F. No. 30th ERC Meeting/MOM/2018 Meeting of ERC, AIIMS, Raipur

Minutes of 30th ERC Meeting of AIIMS, Raipur held on 20.02.2018, Tuesday at 03:00 PM in the Committee Room, Medical College, AIIMS, Raipur

<u>Agenda No. 2:</u> <u>Approval of Extra/Deviation Items (Package I, II & IV) –</u> <u>(with all Supporting Documents)</u>

Deviation Item No. 3:

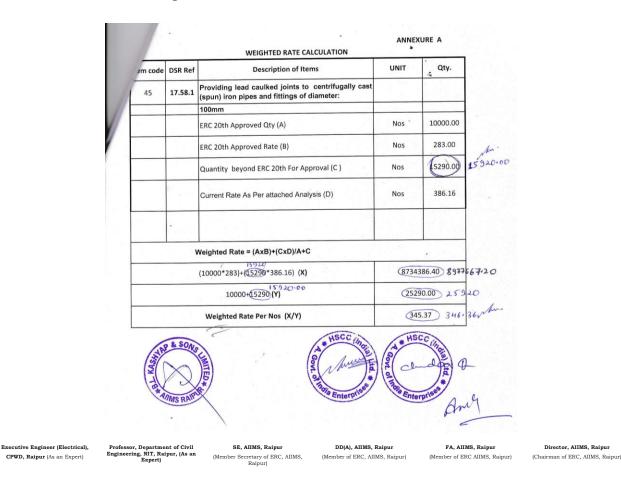
Providing lead caulked joints to centrifugally cast iron pipes and • fittings of diameter: Pig lead 100 mm. (Plumbing Head)

Weighted rate of Rs. 346.36 is being considered for the overall approved quantities i.e. quantities approved in this ERC i.e. 15920 Nos. and quantities approved in 20th ERC i.e. 10000 Nos. Weighted rate calculation sheet is given below:

<u>Remarks / Recommendations from</u> <u>PC, AIIMS, Raipur / ERC of AIIMS, Raipur for Deviation Item No. 3</u>

This item is absolutely required to execute the work of CI Pipes. The quantities as per GFC Drawings issued by old DDPR Consultant i.e. M/s Hospitech /Site Requirement are more than the quantity catered in BOQ. Hence Deviation is justified. The Job will be executed as per GFC approved drawings and Site requirement. Execution of this item shall not lead to any undue benefit to the Contractor. This item is verified, recommended by M/s HSCC (India) Ltd. as PC and DDPRC of AIIMS, Raipur. Payment will be made as per actual work done and measurement at site.

Extra Item No. 9:

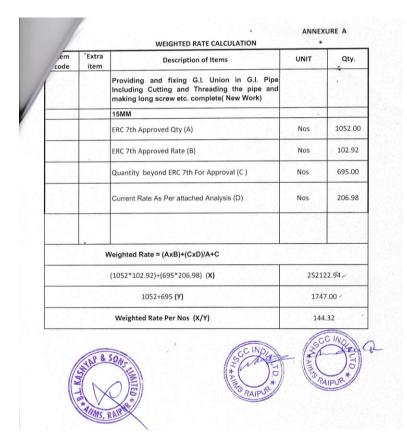
• Providing and fixing G.I Union in G.I pipe including cutting and threading the pipe and making long screw etc. complete (New work). G.I Union 15mm qty as per over and above ERC 7th meeting of AIIMS, Raipur (Plumbing Head)

Weighted rate of Rs. 144.31 is being considered for the overall approved quantities i.e. quantities approved in this ERC i.e. 695 Nos. and quantities approved in 7th ERC i.e. 1052 Nos. Weighted rate calculation sheet is given below:

<u>Remarks / Recommendations from</u> <u>PC, AIIMS, Raipur / ERC of AIIMS, Raipur for Extra Item No. 9</u>

This item is absolutely essential to complete the work. This item is not available in BOQ of Package – I and hence shall have to be provided as an extra item. It is certified by PC, AIIMS, Raipur that the market rate / material and labours as adopted for this statement have been personally verified by M/s HSCC (India) Ltd. as PC, AIIMS, Raipur. It is also certified that this item cannot be got executed through other agency due to interconnected to other agreement items and exigency of work. Execution of this item shall not lead to any undue benefit to the Contractor. This item is verified, recommended by PC, AIIMS, Raipur.
